Environmental Review Team
Report
on
M&L Homes Property
Montville, Connecticut

January 1982

The Eastern Connecticut Environmental Review Team was asked to evaluate a proposed condominium development and zone change in the town of Montville. The site is approximately 50 acres in size and is located on the eastern side of the intersection of Williams Road and Old Colchester Road. Developers for the proposal are M & L Homes, Inc., of Middletown. Preliminary plans have been prepared by J. Robert Pfanner Engineering.

Vegetation

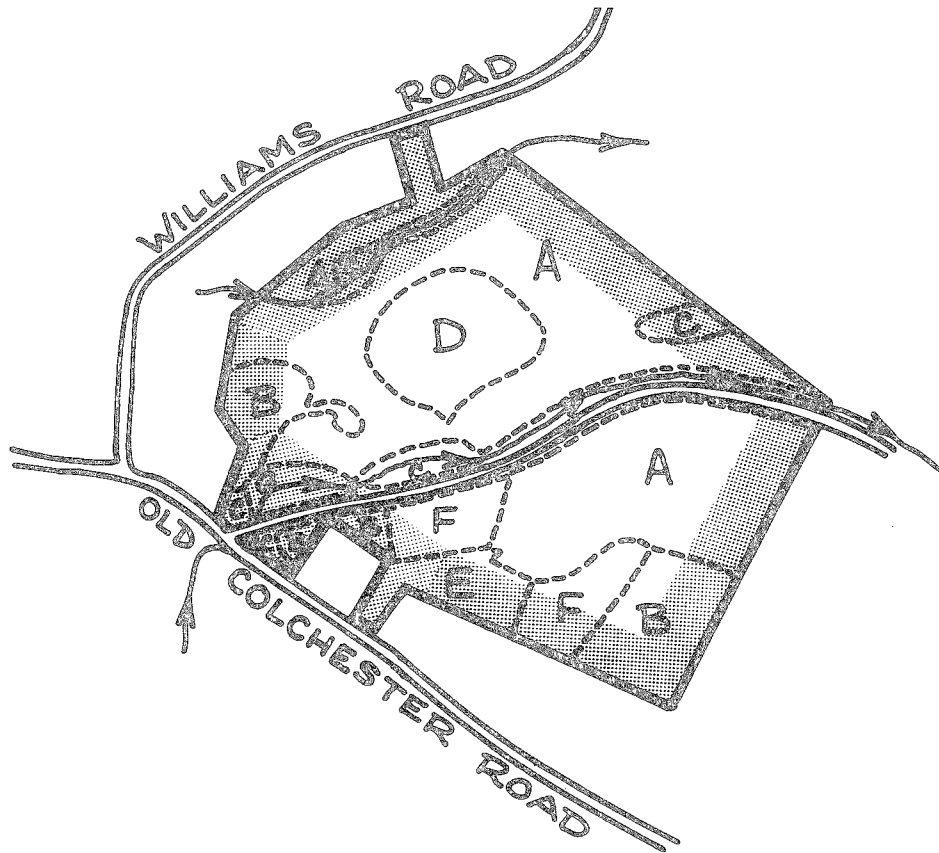
The impact of this proposal on existing vegetation will be significant within this tract. The proposed development of condominium units, roadways and parking lots will necessitate the clearing of much of the vegetation from the area north of the stream and sewerline. It will also necessitate clearing of approximately four acres south of the sewerline for the development of the proposed recreational fields. This widespread clearing of vegetation has the potential to result in accelerated erosion and sedimentation, therefore, a sediment and erosion control plan should be designed and implemented prior to construction on the site.

To help preserve the integrity of the streambelt and open swamp areas, it would be desirable to leave a relatively undisturbed buffer strip of natural vegetation at least 30 feet wide around these areas. This will help to stop sediment and silt generated by the proposed development from reaching these wetland areas and degrading their water quality.

The retention of a relatively undisturbed buffer strip approximately 200 feet wide around this property has been proposed by the developer. This area should help to screen the proposed development from the single family residences to the northwest of the tract. To improve the effectiveness of this area as a visual barrier, it would be desirable to under plant with eastern hemlock or a combination of eastern hemlock and eastern white pine. These seedlings should be planted between 10 and 15 feet apart. Once established, these evergreen trees will provide a more complete barrier which will be effective throughout the year. This planting will also improve the value of the area for wildlife by providing high quality cover.

The larger trees which were left in Vegetation Type A (mixed hardwoods) at the time of the last harvest and many of the trees in Vegetation Type D (mixed hardwoods) are of very poor quality or damaged. Removal of these poor quality trees for fuelwood from areas not proposed for intensive development would be feasible. This improvement thinning will reduce competition between residual trees for space, light, water and nutrients, resulting over time in improved tree health and vigor.

The trees which are present in Vegetation Type F (mixed hardwoods) are at present declining in health and vigor due to their crowded condition. These trees will respond well to a thinning using the "crop tree selection method."
